**Addendum No. 1
to the Bidding Documents for**

BID PROPOSAL #09-15

**Hobbs Hill Water Tank Replacement
City of Portsmouth Department of Public Works
Portsmouth, New Hampshire**

Issued September 8, 2014

GENERAL NOTES

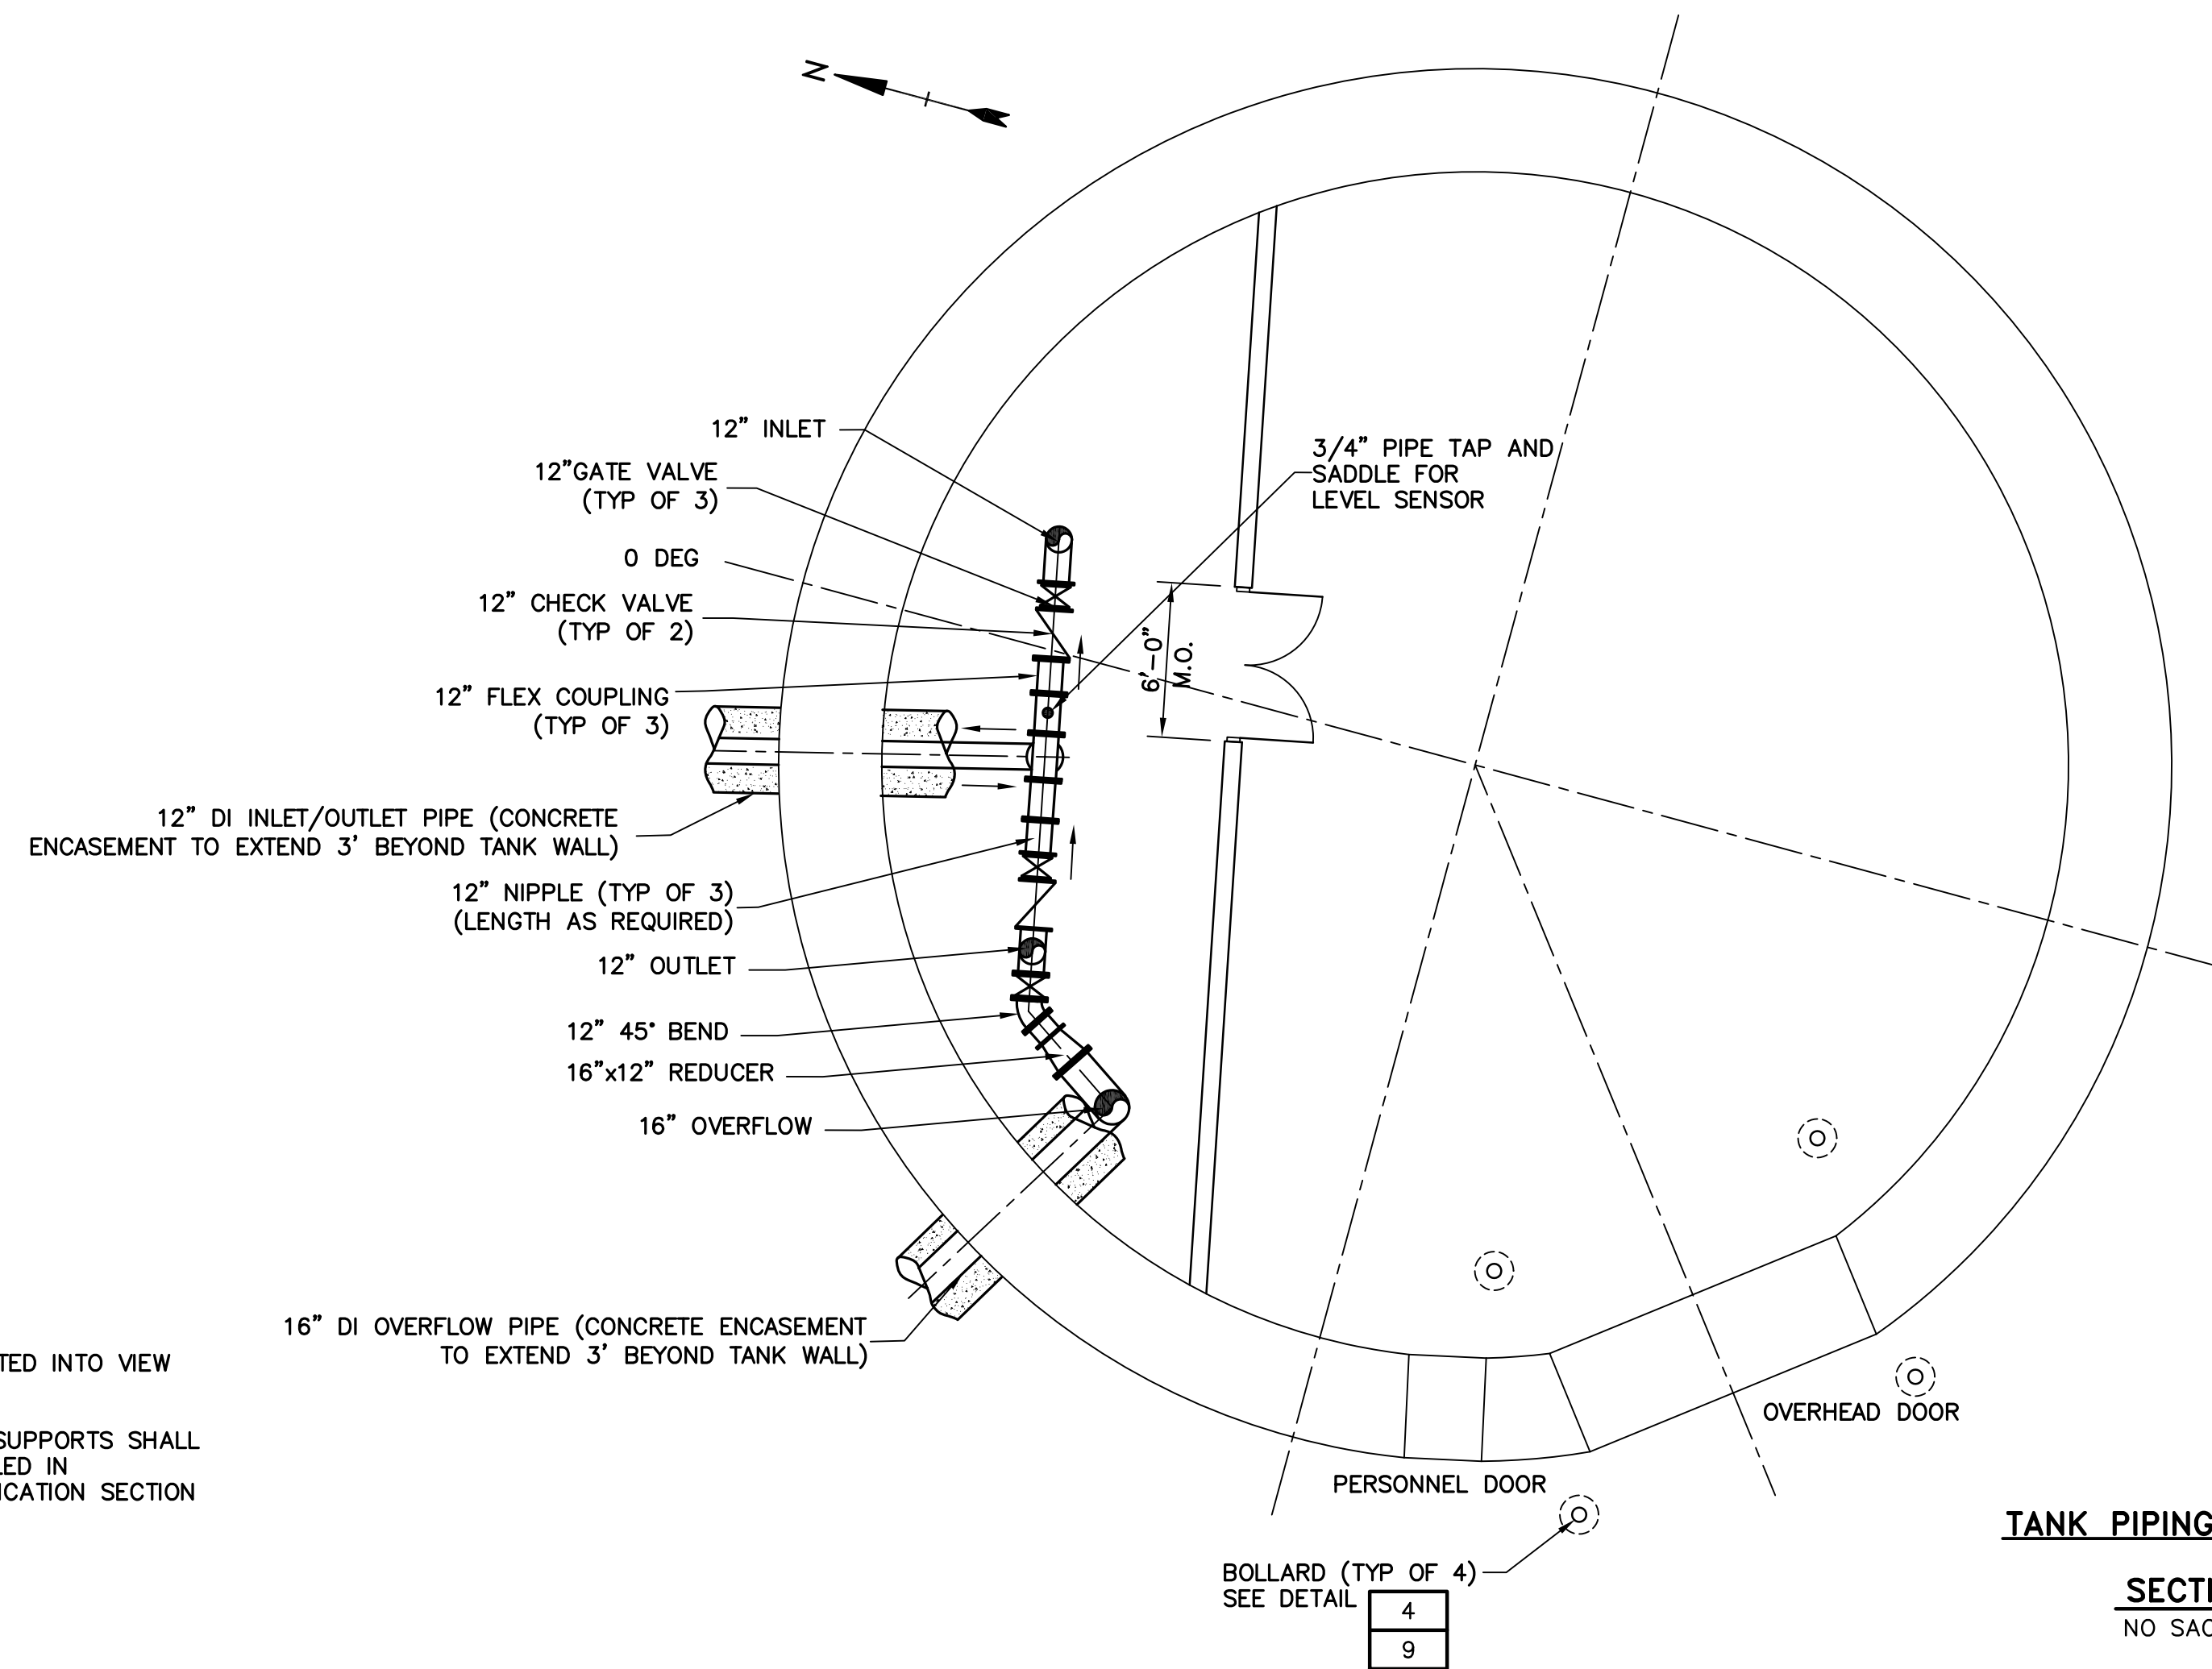
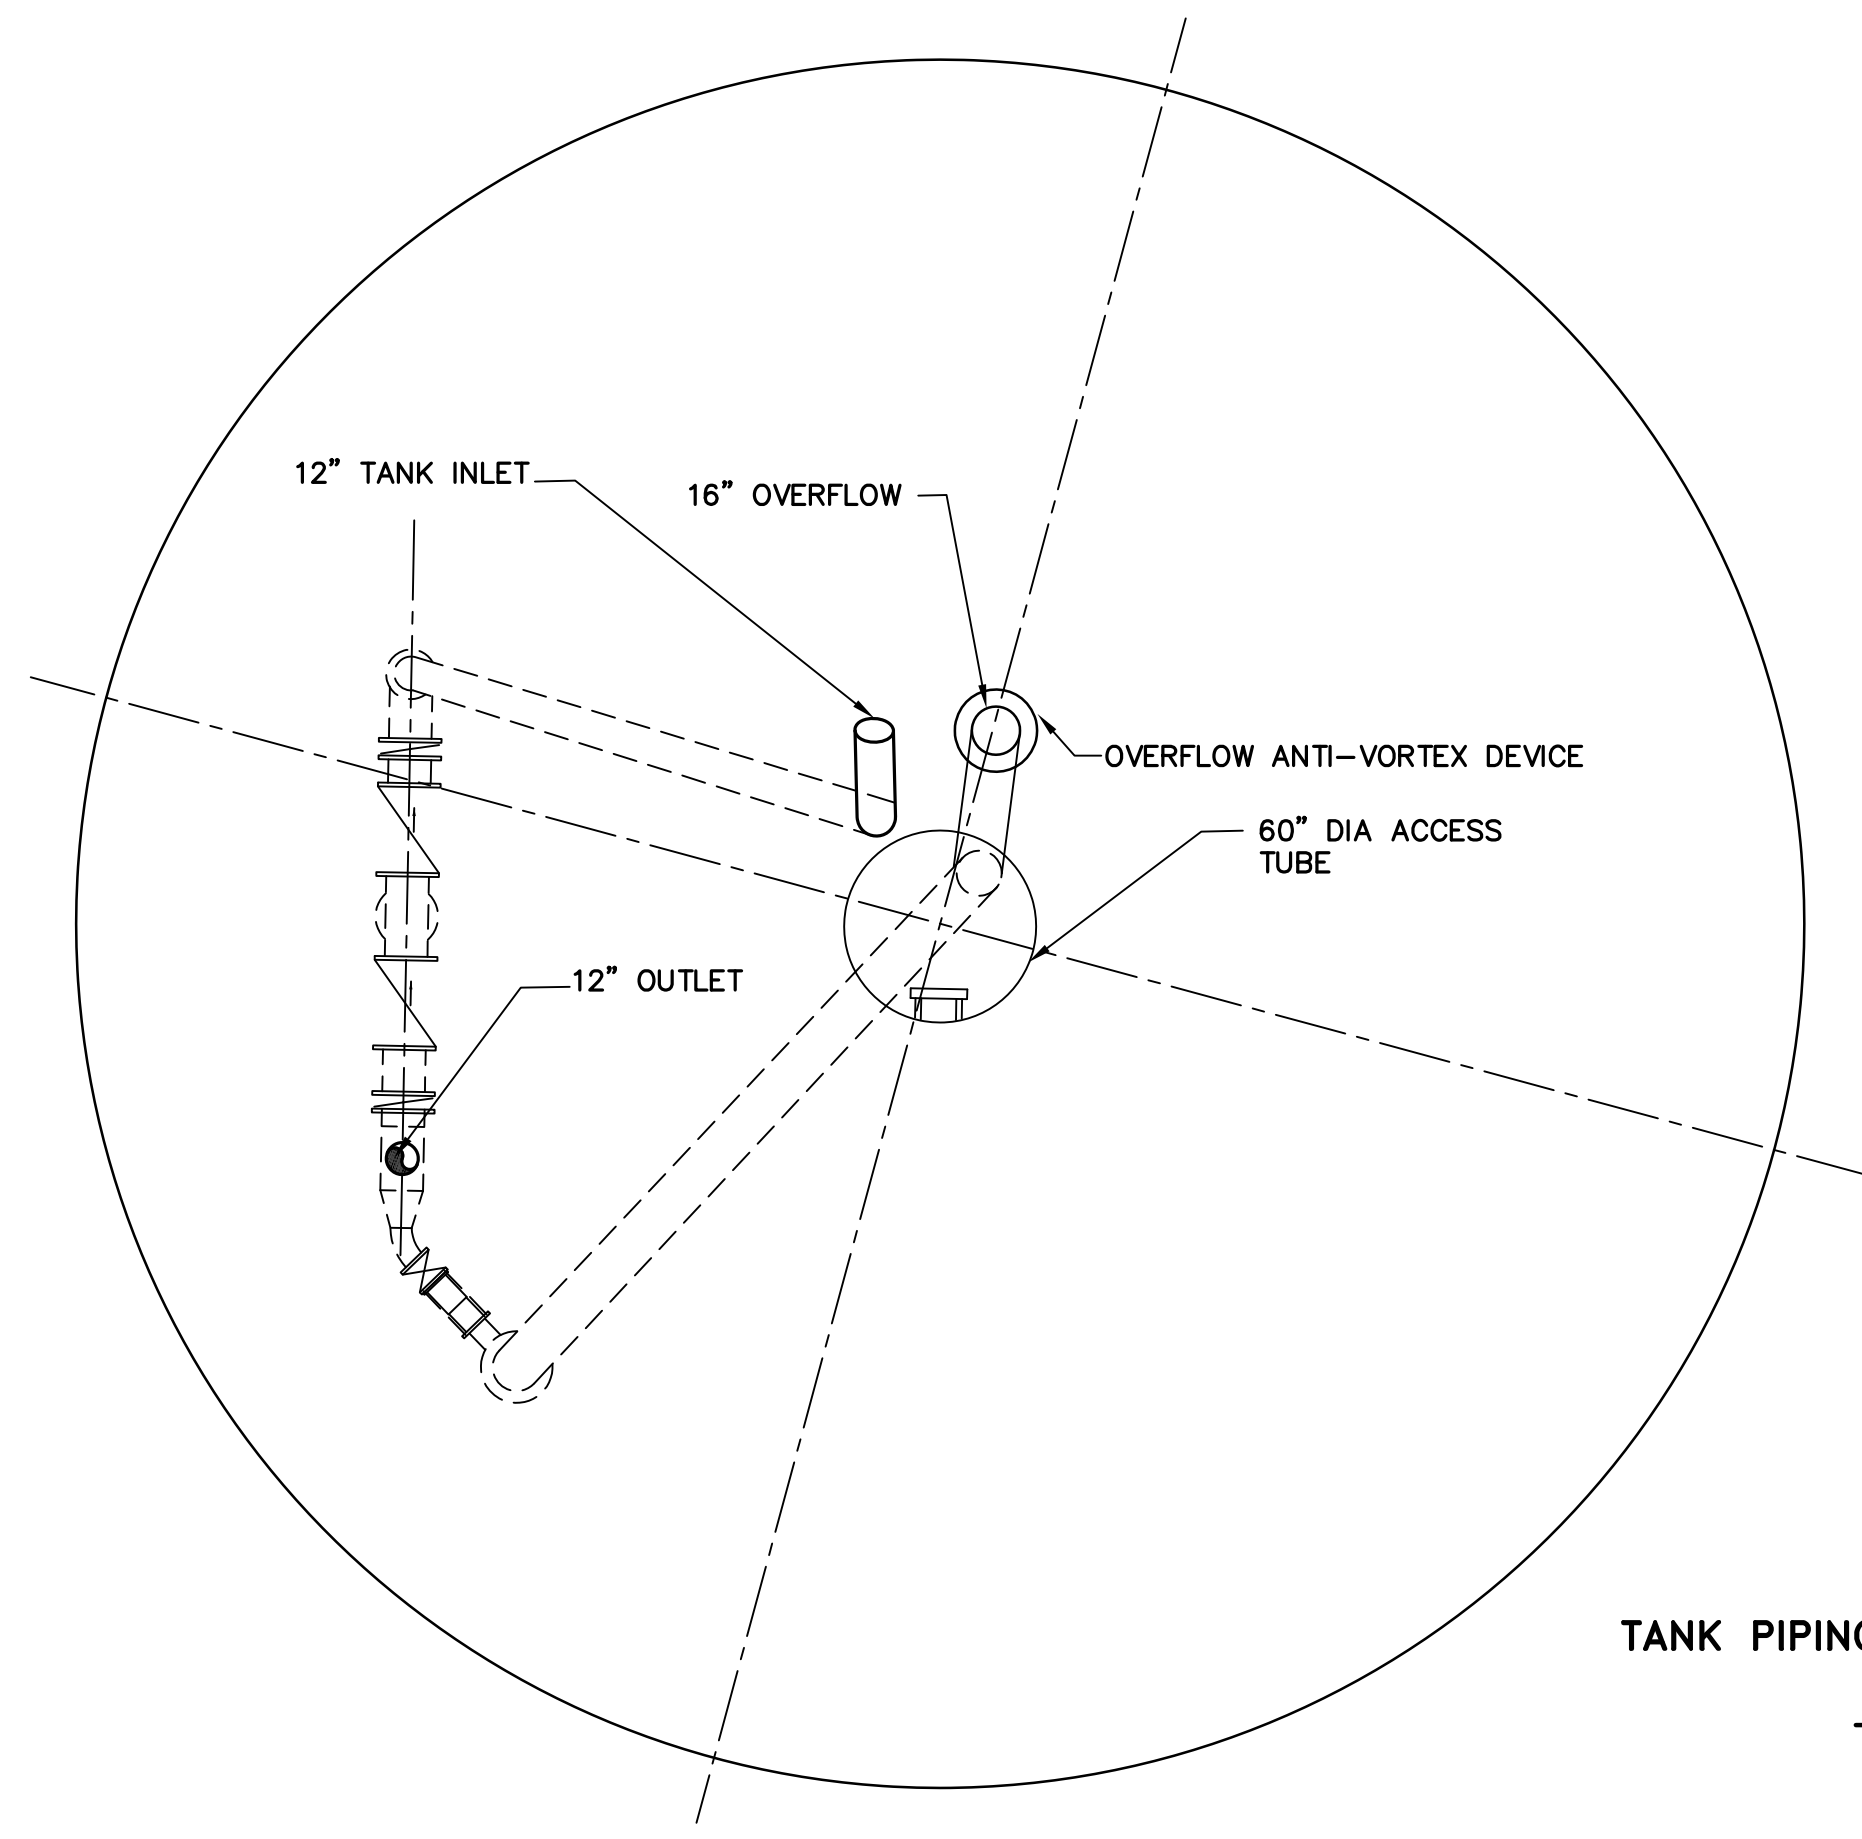
5. Can we use our standard head range of 33' (Sheet 6, Elevation and Section 13210 1.7 B)?

6. Can the overflow pipe be on the exterior of the access tube (Sheet 6, Elevation)?

The overflow pipe is currently shown as a welded penetration through the side of the 60-inch diameter access tube. The advantage is it eliminates one flanged penetration through the concrete tank bottom, which T&B believes is a greater long term maintenance issue as compare to the fabricated penetration through the access tube. An alternative configuration consisting of an overflow pipe internal to the steel tank (exterior of the access tube) and penetrating through the concrete tank

7. Can we use our galvanized rest platforms in lieu of aluminum rest seats (Sheet 6, Elevation and Section 13210 2.5 D.1)?

31. Page 13210-14 specifies a 10'x10' overhead door as does drawing sheet 6. Drawing sheet 10 specifies a 12'x12' overhead door. Please clarify door size.

32. Drawing sheet 6 shows overflow piping going through access tube. Our typical overflow pipe does not go through the access tube. Please clarify that this is acceptable.

44. The Masonry wall inside the pedestal of the tank shown on sheet 6 has no height associated with it. Please provide.

54. Sheet 6 shows the incoming waterline passing over the foundation. Our design will incorporate the incoming waterline into the foundation. Please confirm this is acceptable and we are not required to place the foundation deeper than required by our design to allow the waterline to pass over the foundation.

The following alternative Operating Parameters as described Section 13210 1.7 B will be acceptable:

Operating range (min. - max.)	25-34 feet
Bottom of Tank Bowl Elevation	196 feet minimum

bottom would be acceptable, conditional upon approved shop drawings, if it is demonstrated that it addresses the long term maintenance concerns.

Yes - galvanized rest platforms can be used in lieu of aluminum rest seats.

The overhead door size shall be 10 feet by 10 feet.

Refer to response to question #6 above.

Ceiling height shall be not less than 7'-6".

The proposed foundation the design will need to accommodate the incoming waterline configuration and these details are to be addressed as part of the shop drawing review/approval process.
